Subject: REAR MOUNT CAMERA DOES NOT OPERATE	Bulletin No: 09-016/14
	Last Issued: 02/25/2014

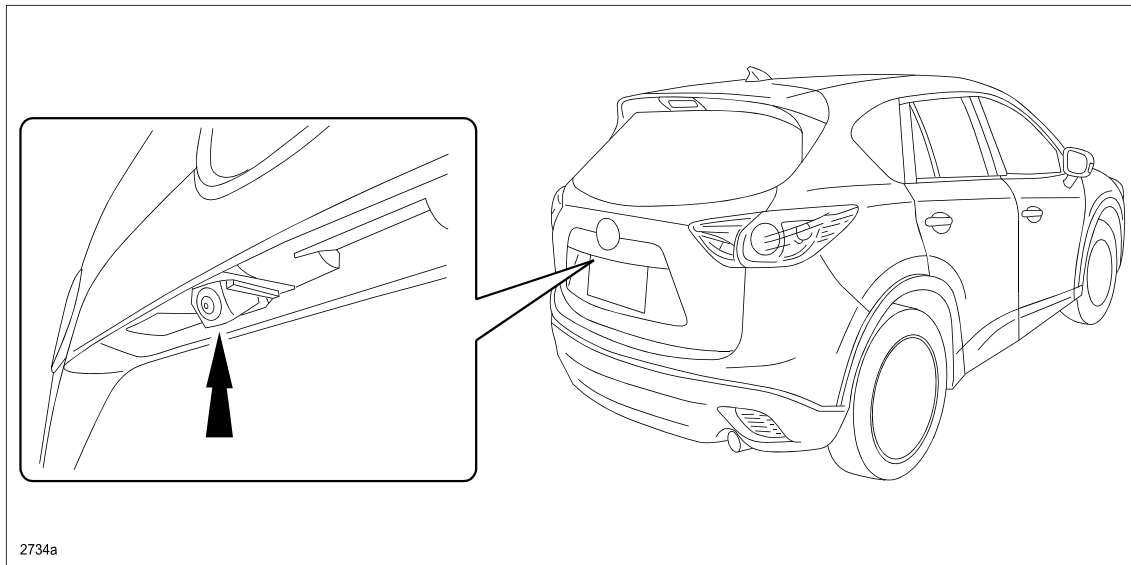
Some vehicles may exhibit an inoperative rear mount camera. This concern may be caused by water entering inside the camera during a high-pressure car wash.

The shape of the camera has been changed to eliminate this concern.
